RE: *Grading and Drainage Plan for Blair Residence, Lot 28, Block 18, Tract 2, Unit 2, North Albuquerque Acres, (D22/D30) (PWDN-990133), Engineer's Stamp Dated 6/25/99.*

Based on the information provided, the above referenced plan dated June 25, 1999 is approved for Building Permit release.

GRADING & DRAINAGE PLAN

RIPRAP CHANNEL LINING

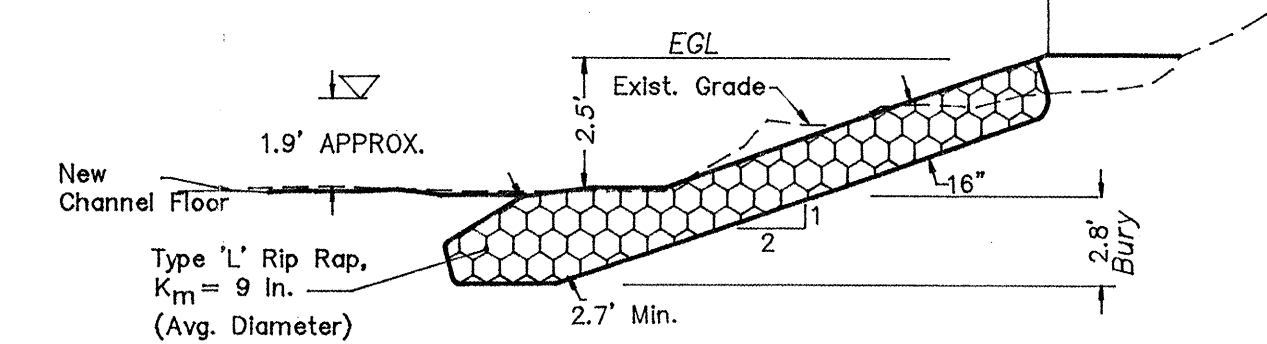
As you are aware, the Engineer's Certification is required prior to release of the Certificate of Occupancy for this residence. The certification must include verification that the proposed rip-rap channel lining has been constructed in accordance with this approved plan.
